Submissions Report

WELLINGTON SOLAR FARM

MARCH 2018

Figure 3-2 Updated constraints mapping, reflecting new layout and additional assessments presented in this Submissions Report.

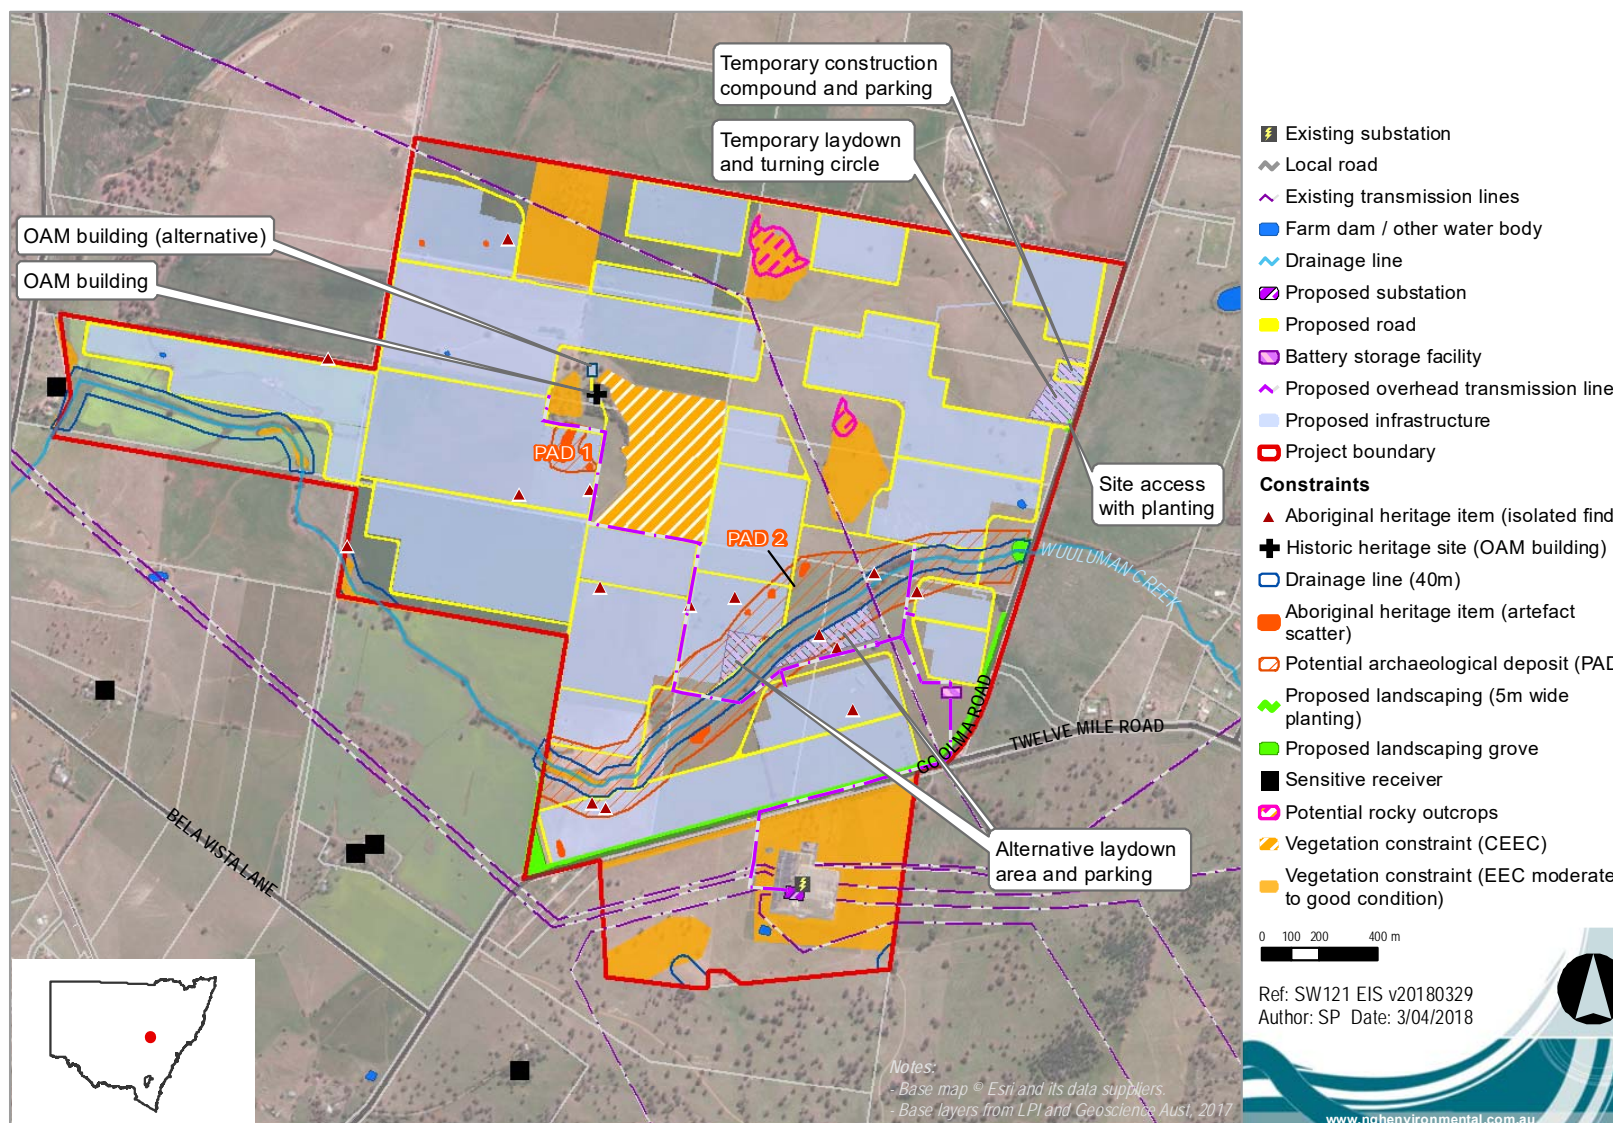
Issue	Detail of issue	Proponent response
6.1 DEPARTMENT OF PLANNING AND ENVIRONMENT (DPE)		
Revised disturbance areas	Describe the revised layout, noting the CEEC will be avoided. Confirm which substation option will be used and revise the project boundary to reflect the final option.	<p>The updated indicative layout and constraints map is provided in Figure 3-2. The changes are:</p> <ul style="list-style-type: none"> • The project footprint has been reduced to reduce impacts on a CEEC. The overall reduction on this community (which is now entirely avoided) is 2.075 ha. The overall reduction on native vegetation impacts is 9.83 ha. • The alternative substation location south of the Energy Storage Facility (ESF) has now been deleted. The substation would be located in the western part of the existing substation within the substation boundary fence. • The 33kV feeders from the solar farm will run underground along the boundary of the solar farm, under Goolma Road and into the substation, reducing the visual impact of additional overhead power lines. • An additional option has been included to construct a purpose-built Operations and Maintenance building near the onsite residence. This option is required in the event that upgrades anticipated for the historic structure are not cost effective or in keeping with the heritage restrictions on this structure.

Further information required to make assessment	Layout of internal road network, parking facilities and infrastructure within project boundary.	<p>The proponent has provided an updated layout (Figure 3-2) showing the internal road network, parking facilities and infrastructure within project boundary.</p> <p>No changes to the EIS mitigation measures are proposed.</p>
Further information required to make assessment	<p>In their response, Roads and Maritime restated the need to provide information requested in their SEARs provided 30 June 2017. Roads and Maritime SEARS included the following additional items:</p> <ul style="list-style-type: none"> A Traffic Impact Study prepared in accordance with Section 2 of RTA's Guide to traffic 	<p>The proponent discussed the request by RMS for further information. RMS's key issue was traffic numbers and management as addressed above. The proponent's understanding is that no further action was required. Specifically:</p> <ul style="list-style-type: none"> As separate TIS is not required. Additional road improvements are not required. Further consideration of local climate is not required.

The updated indicative layout and constraints map is provided in Figure 3-2.
